## MARICOPA COUNTY Department of Transportation

**MEMORANDUM**

Subject: Revision to Detail 251 RETURN TYPE DRIVEWAYS Case 16-03

PURPOSE: Adjust concrete thickness and concrete class for commercial and industrial

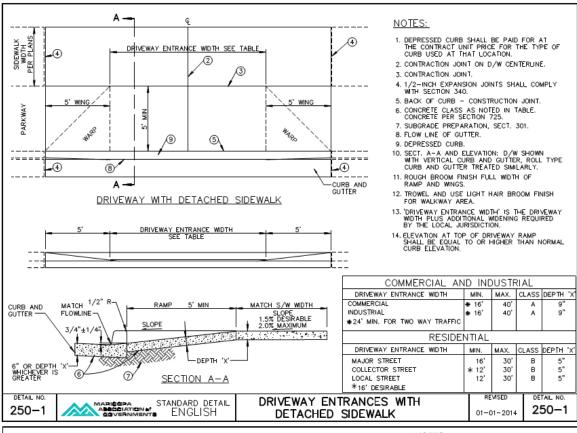
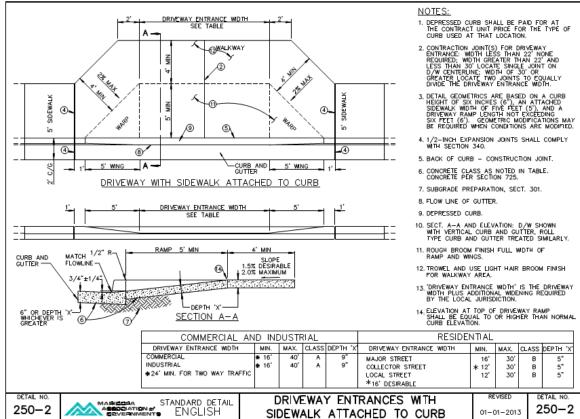
**REVISIONS:** Change concrete thickness from 6" to 9" for commercial and industrial driveways. Change concrete from Class B to Class A for commercial and industrial driveways. Clarify payment limits for curb & gutter and for the driveway.

WING TYPE ALLEY ENTRANCE (WITH ROLL TYPE CURB AND GUTTER)

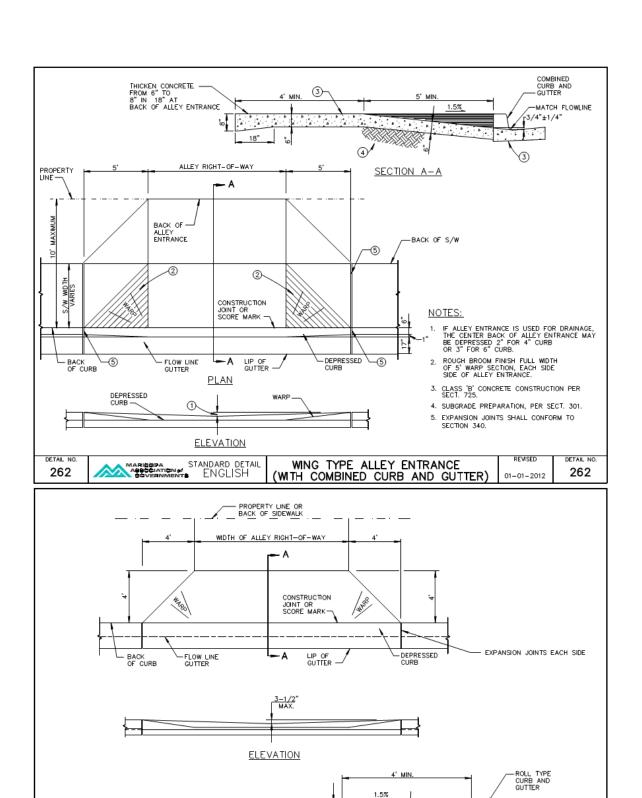
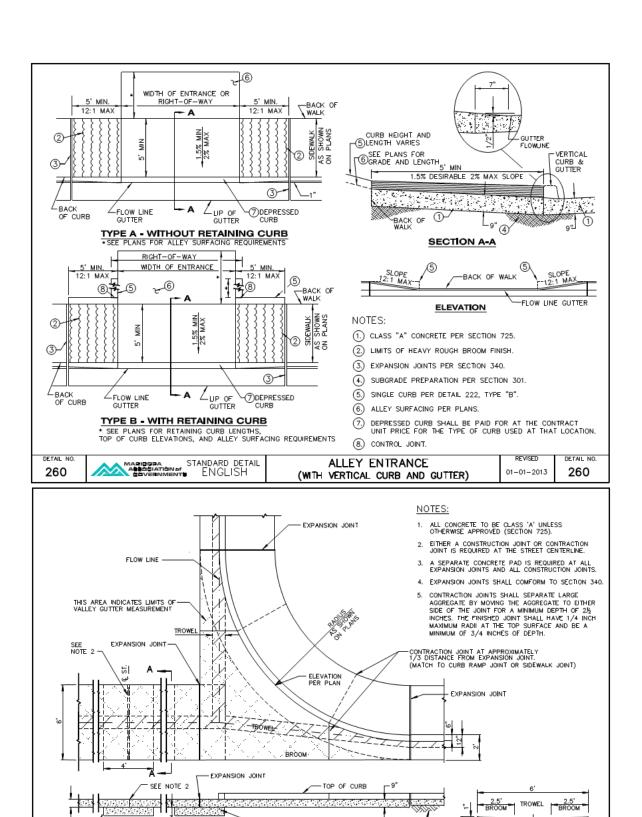
**QUESTIONS:** Should the same changes be made to alley entrances Details 262 and 263? Should residential driveways be deleted from Detail 251?
